SITE PLAN REVIEW AND APPEARANCE BOARD

Meeting: August 14, 2019 | File No.: 2019-148-SPF-SPR-CLIV | Application Name: Buddha Skybar

The action before the Board is for the approval of a Class IV Site Plan modification for Buddha Skybar pursuant to LDR section 2.4.5 (G)(1)(d) and section 3.1.1, including the following:

SP.1
SHEET NO.

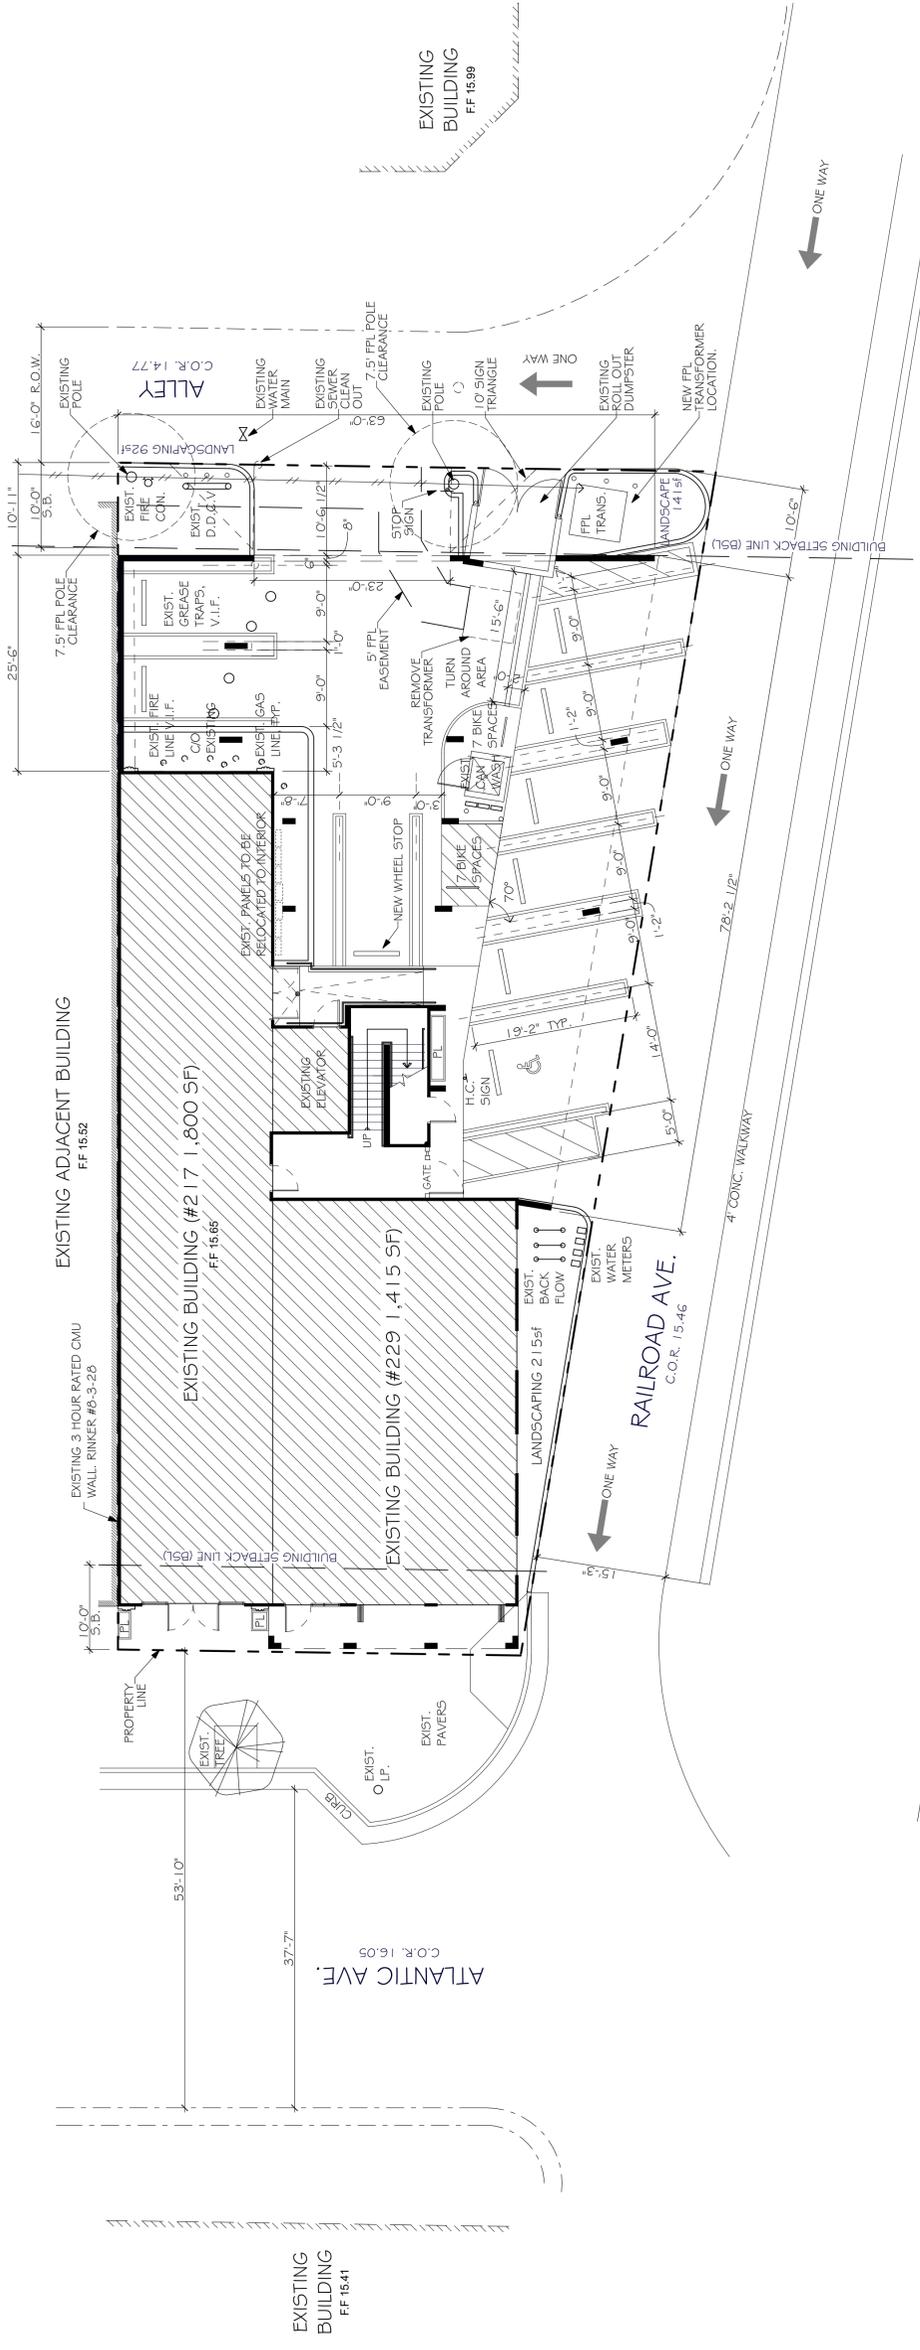
- Site Plan SP.1 shows a proposed lateral connection into an existing water main along the rear alley way.
- Site Plan SP.1 shows a proposed lateral connection into an existing sanitary sewer main along rear alley way.
- Pursuant to the City’s Comprehensive Plan, treatment capacity is available at the City’s Water Treatment Plant and the South-Central County Wastewater Treatment Plant for the City at build-out. Based upon the above, positive findings can be made with respect to this level of service standard.

2ND FLOOR & DECK
A1.2
SHEET NO.

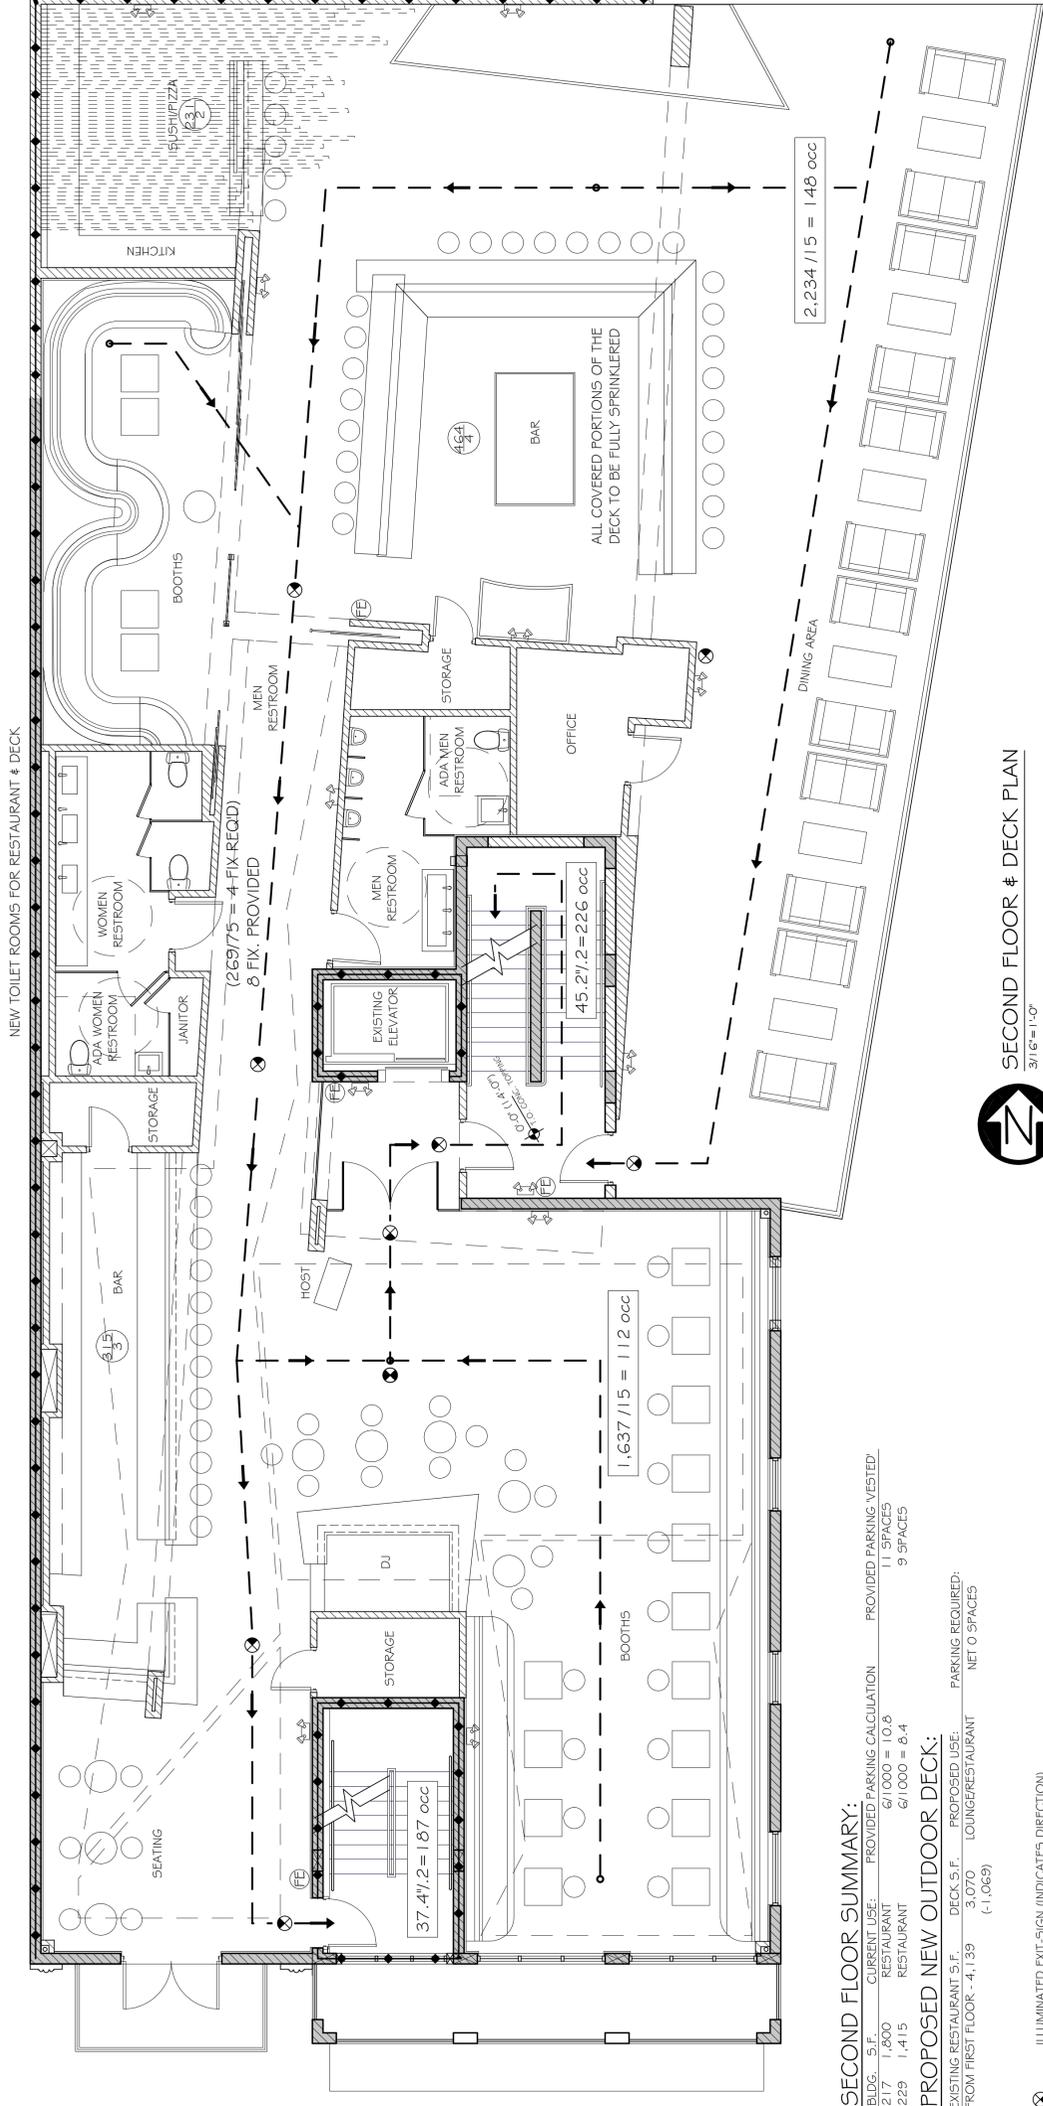
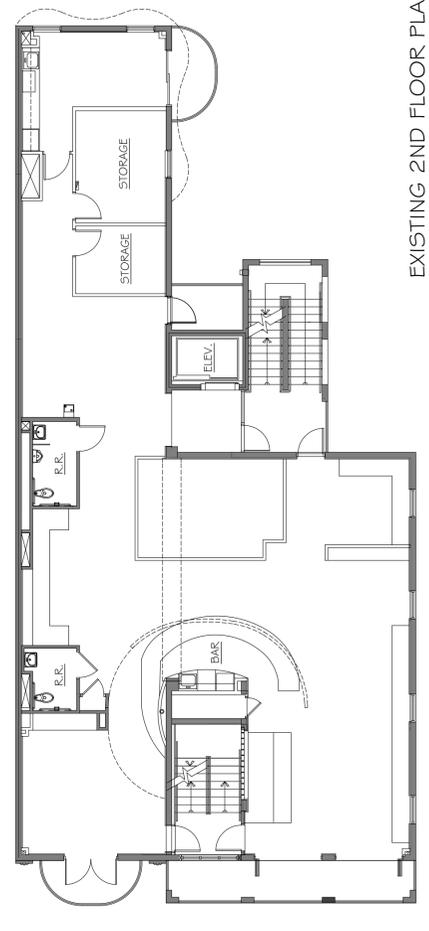
- Plan pages A1.10 and A1.2, show minor landscape improvements consisting of the removing and replacing of existing plants and trees on site. The landscape modifications have been reviewed by the City's Senior

A2.1
SHEET NO.

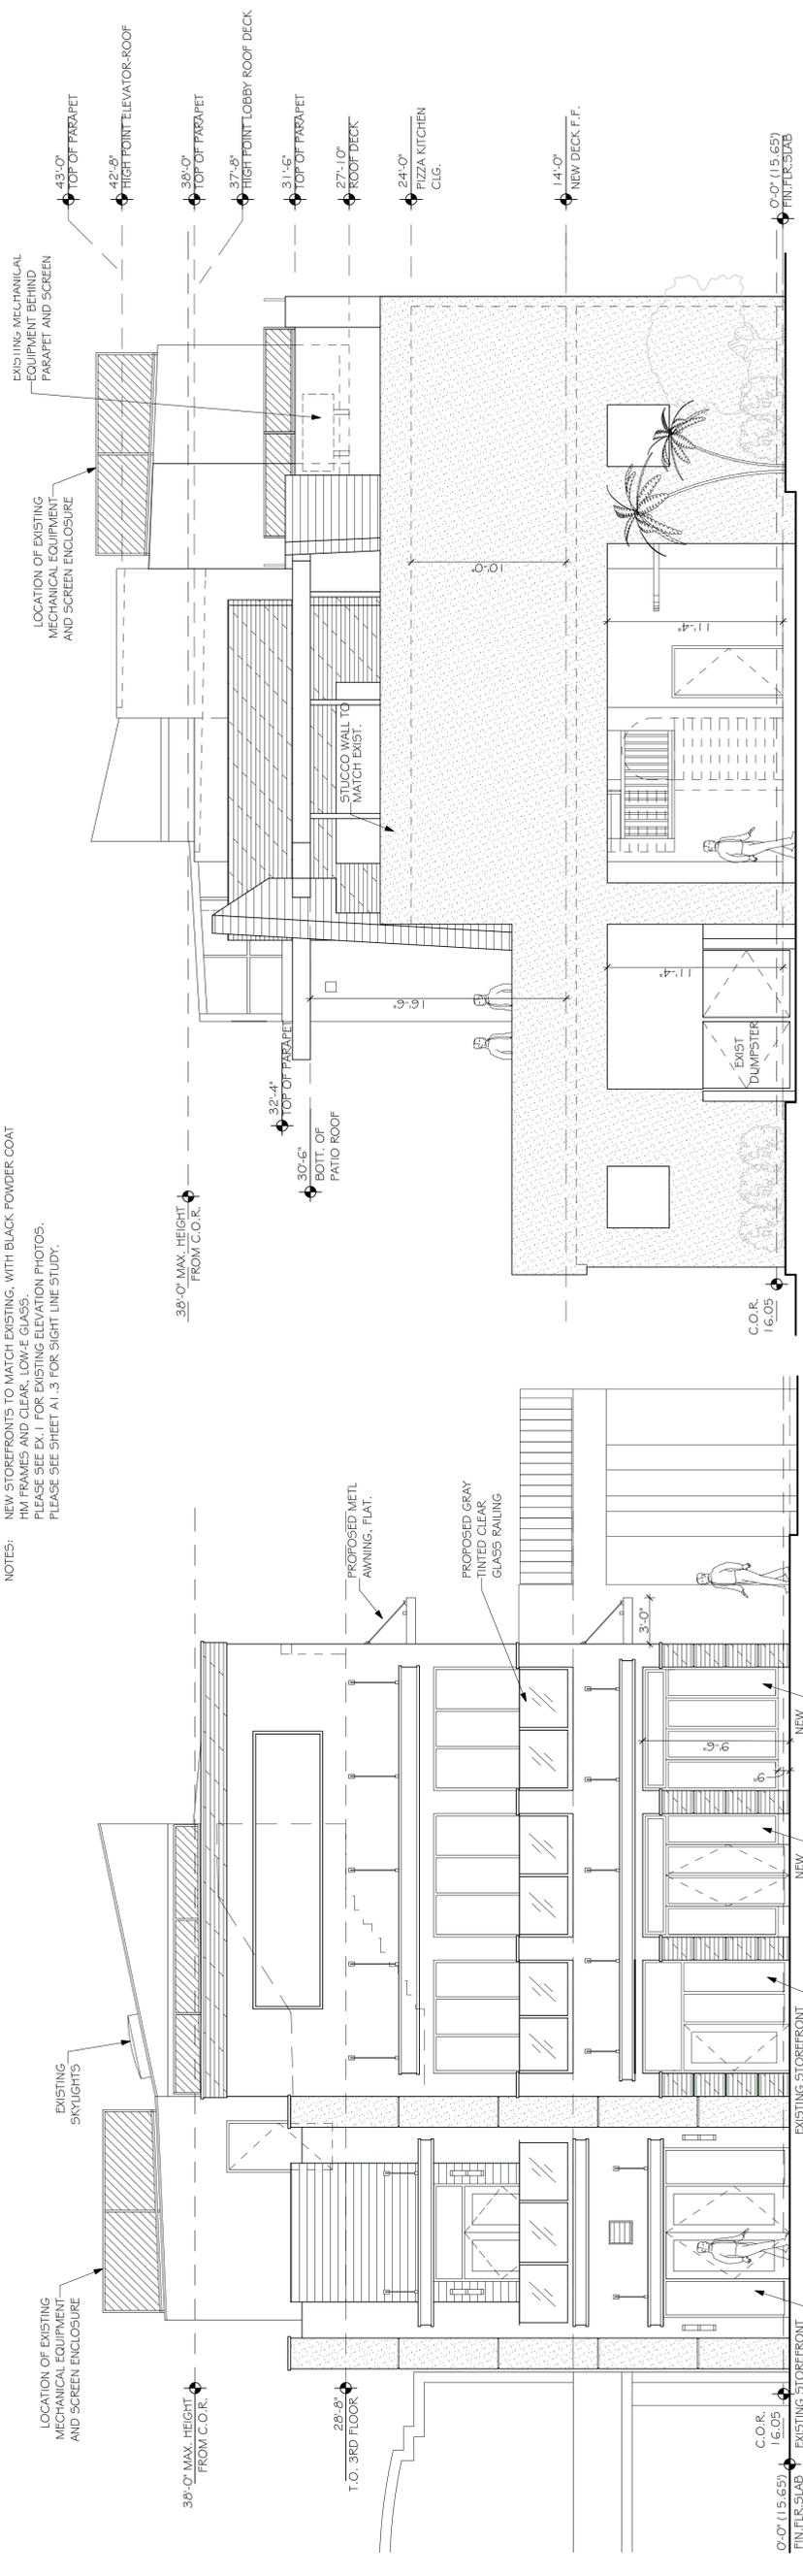
The 2nd floor outdoor dining deck addition introduces irregular angled shapes to the buildings design. The accent wall shown vertically on elevation page A2.1 appears to reflect the shape of the floor plan of the outdoor deck. The overall building design uses angular shapes throughout the building's design, both on the existing structure and the proposed addition. The addition includes "Prodex Rustik" wood clad walls, gray color scored walls, pure white stucco walls, glass railings and a canopy roof structure covering the outdoor bar area.
